3 COMMENTS AND RESPONSES

3.4 PRIVATE INDIVIDUALS COMMENTS AND RESPONSES

This section includes comments received from individuals in letters and emails. Comments are delineated with responses to each comment.

Figure 1 Project Overview

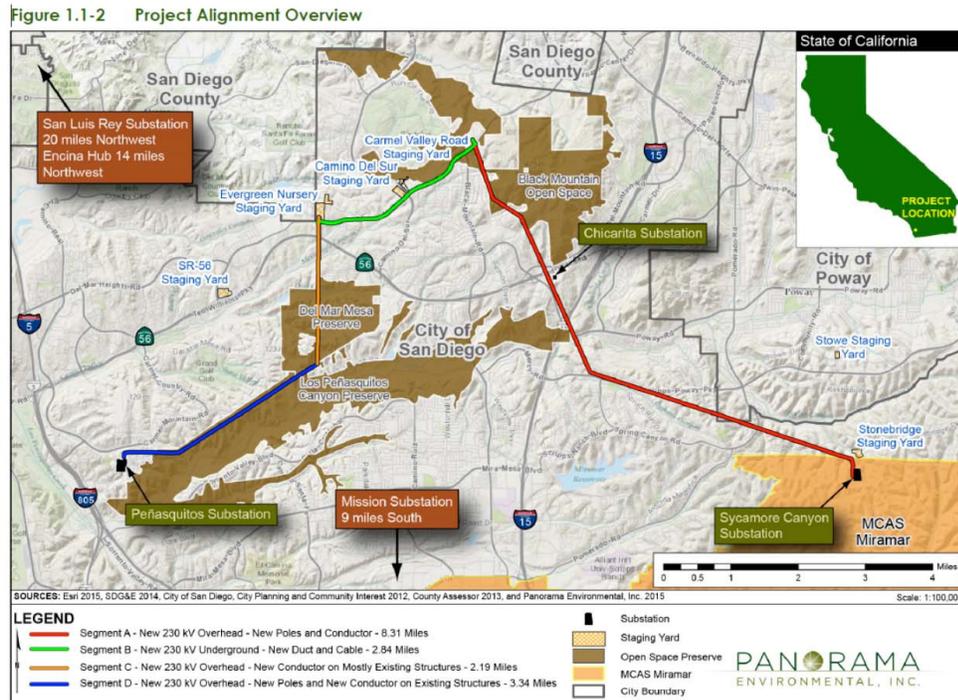
I am a homeowner near Segment D of this project. Segment D is shown in blue in Figure 1 below.

Figure 3 Current EMF Measurements from SDG&E at my address (Lot 29)

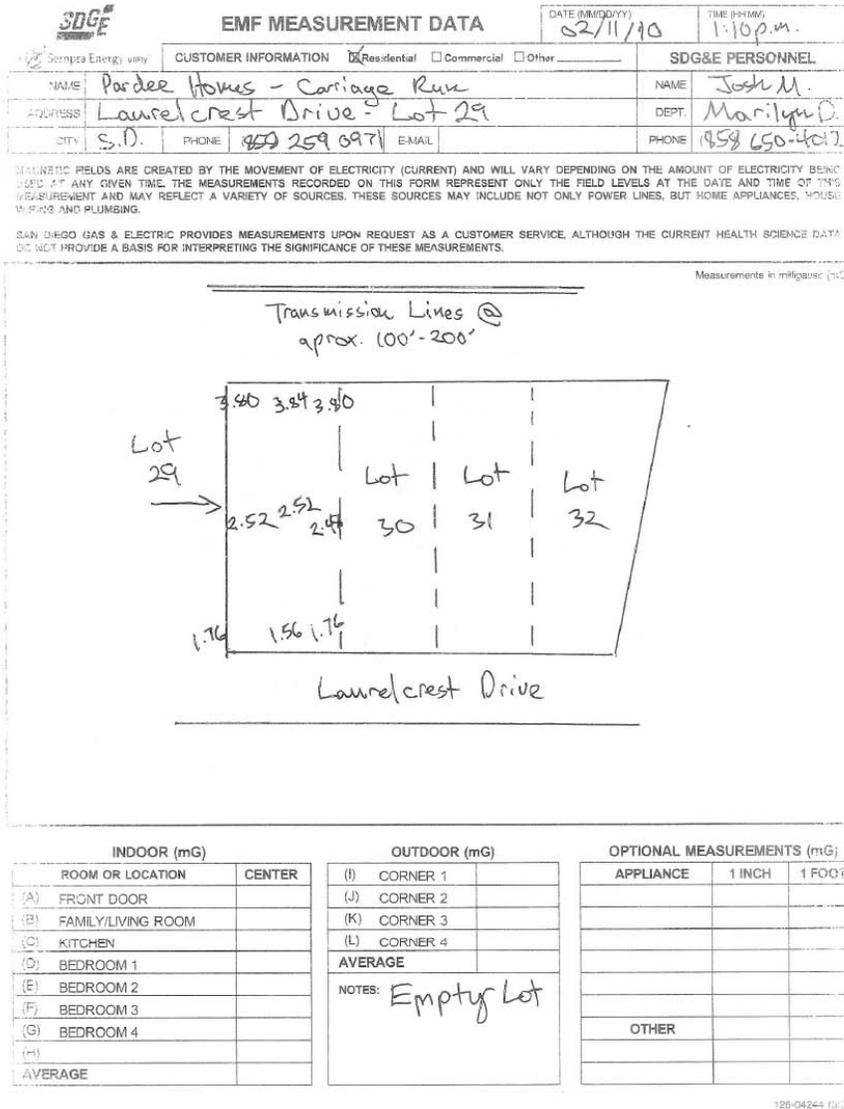
C105-3 | These changes represent a very real health concern for me and my family, as well as my
 C105-4 | neighbors. Increasing the EMF levels will also result in a lowering of property values in the area.
